ASSESSMENT REPORT

NEW EDUCATION BUILDING, WENONA SCHOOL SSD 6952 MOD 3

Figure 9: Judith Dey Wing elevation (source: Application documents, 2018)

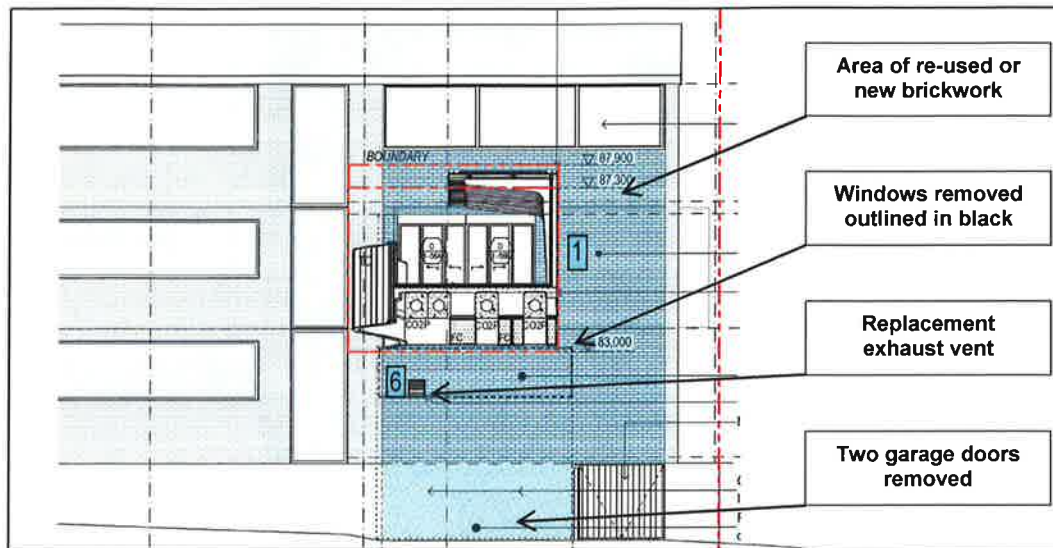
The proposed modifications include the removal of windows and two redundant garage doors, reinstatement of wall with existing or new matching brick work and installation of a new exhaust vent to replace existing vents.

The Department notes that the modifications are required to make-good the section of the building impacted by the construction of the replacement pedestrian bridge. Existing bricks would be re-used or new bricks used to match the existing. In the case of the removal of the garage doors, new brickwork would be used, rendered and painted to match the adjoining retained garage door which would be refinished. On this basis, the Department is satisfied that the proposed modifications would be consistent with the character of the existing building and would not have any significant adverse impacts on the amenity of the area.

The Department further notes that the proposed exhaust vent would replace four existing vents on the affected section of wall. It would not therefore result in any new significant environmental impacts.

**Figure 12: Approved section A-A
(Source: SSD 6952 MOD 1, 2017)**

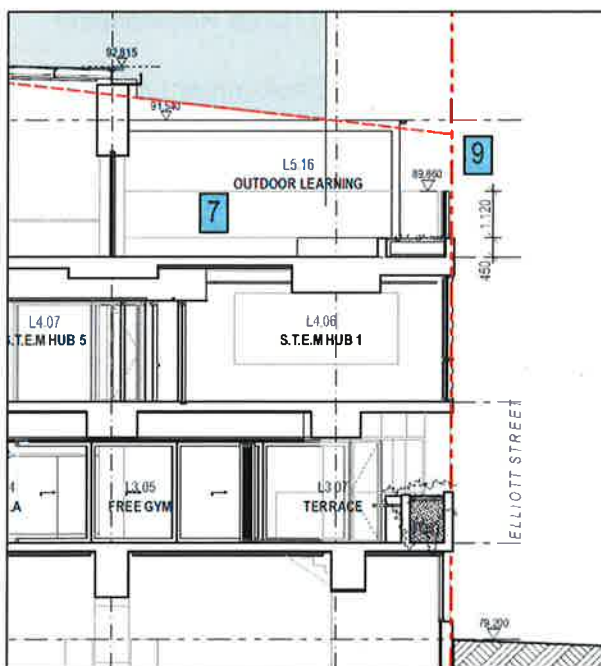
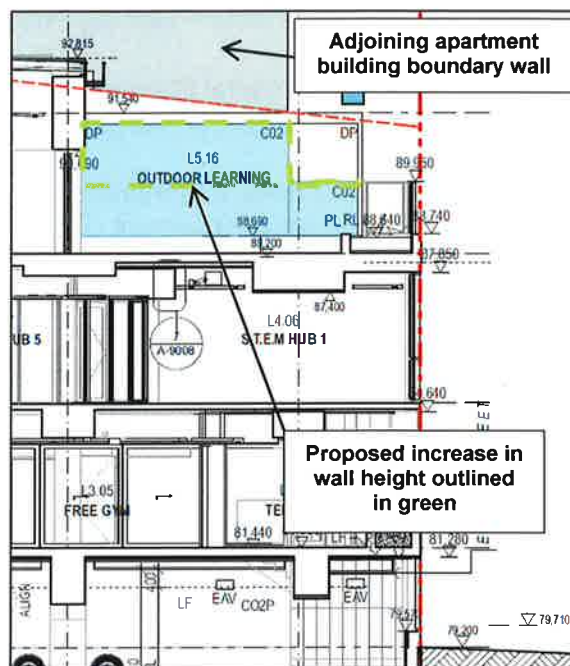
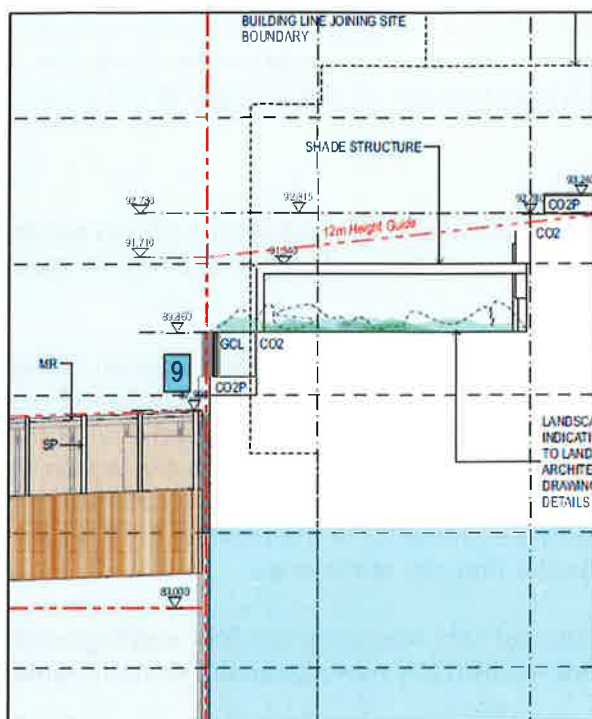
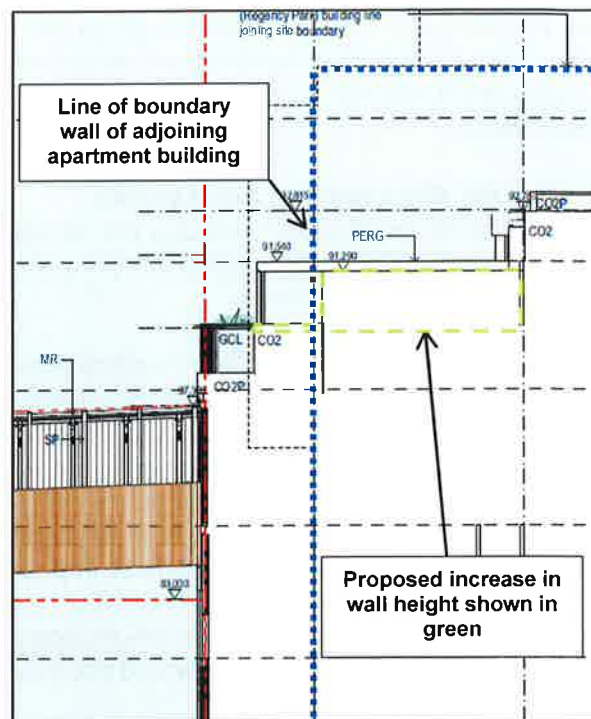
The proposed increase in the height of the northern wall of the new education building involves a short extent of the proposed boundary wall adjacent to the outdoor learning area on Level 5. The Applicant advises that the height change is proposed to improve the aesthetics of the outdoor learning area and waterproof the northern end of the covered space.

The bulk of the new section of wall would be against the existing boundary wall of the apartment building immediately north of the site. The remaining section involves a minor increase in height (RL 89,860 to 89,950) of the balustrade which projects beyond the adjoining building line. The approved arrangements and proposed modifications are shown in more detail in **Figures 12 to 15.**

The Department is satisfied that the section of new wall against the boundary of the adjoining apartment building would not be readily visible from outside of the site and would not therefore have any adverse impacts on neighbouring properties. While it is noted that the balustrade would be visible from Elliot Street and the balconies from the adjoining apartment building, the change in height would be minimal and would not be readily noticeable. Furthermore, the change would not affect solar access to the adjoining balconies given the orientation of the site. Consequently, the Department is satisfied that the proposed increase in wall height would not have any significant adverse environmental impacts and is acceptable.

Figure 16: Proposed entrance gate location
(Source: Application documents, 2018)

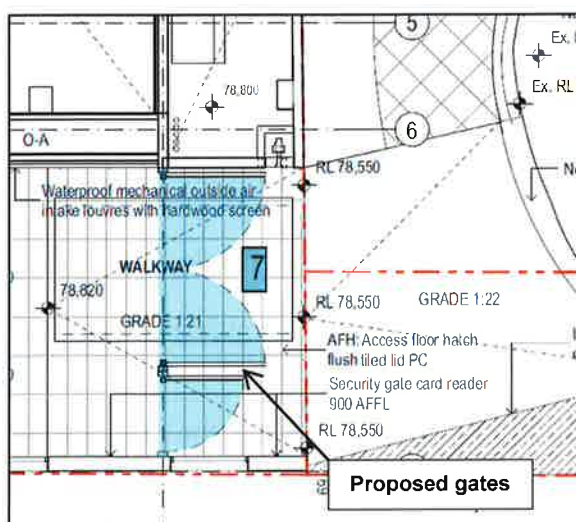
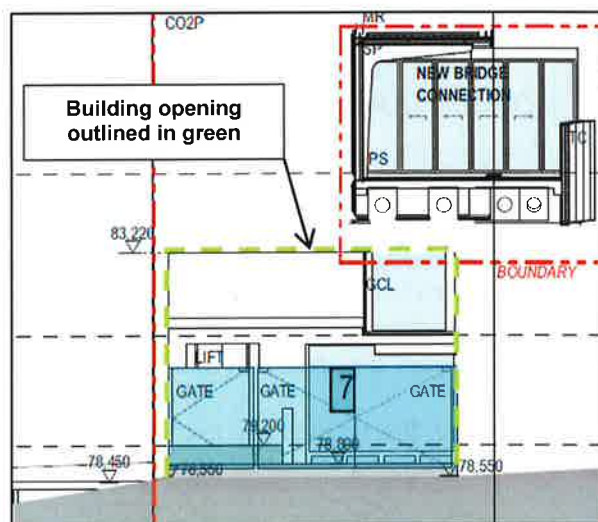
The proposed gates to the Elliot Street entrance would be positioned within a building opening in the eastern elevation and inset so that they would be fully contained within the site when open. The proposed gates would comprise of one single leaf and one double leaf swing gate. The gates would be electronically controlled and allow for views into the site. See **Figures 16** and **17** for the proposed layout and elevation.

The Department considers that the proposed positioning of the gates would be appropriately subservient to the main building and would not significantly alter the appearance of the site. It is considered that the proposal would not have adverse impacts on the amenity of the area or streetscape.
